Intel[®] 80314 I/O Processor Companion Chip

Specification Update

| *July 2005*

Order Number: 273759-010US

Figure 1. Power-Sequencing Requirements

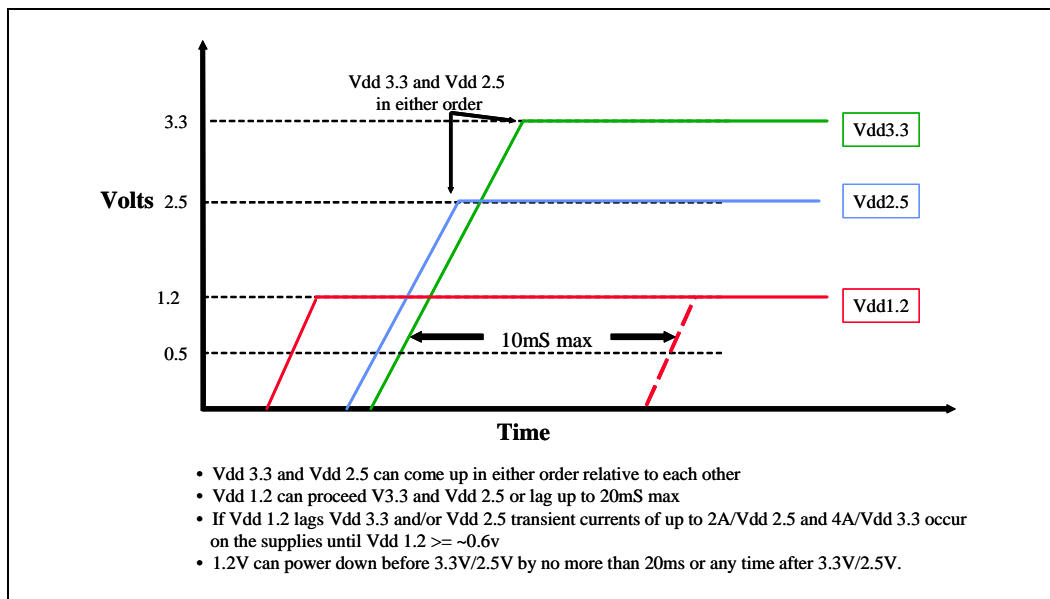
7. Power-sequencing requirement

Issue: The power-up and power-down sequences of the 80314 1.2 V/2.5 V/3.3 V supply rails has been revised from version 003 and 004 of this specification update. The power sequencing requirements initially presented in version 003 were designed to avoid transient current draw that could appear on the 2.5 V/3.3 V supply rails. Further investigation has determined that no current transients occur when the 1.2 V supply is ramped first. In addition, it is acceptable to ramp the 1.2 V supply after the 2.5 V and 3.3 V supplies as long as the lag is less than or equal to 20 mS. When the 1.2 V rail lags the 2.5 V and/or 3.3 V rail, transient currents of up to 2 A/V_{DD2.5} and 4 A/V_{DD3.3} can occur on the supplies until V_{DD1.2} >= ~0.6 V. The 1.2 V supply can power down no more than 20 ms before or any time after the 3.3 V/2.5 V supplies power down. These requirements are illustrated in Figure 1.

Affected Docs: *Intel® 80314 I/O Processor Companion Chip Design Guide* (Section 11.1)
Intel® 80314 I/O Processor Companion Chip Datasheet
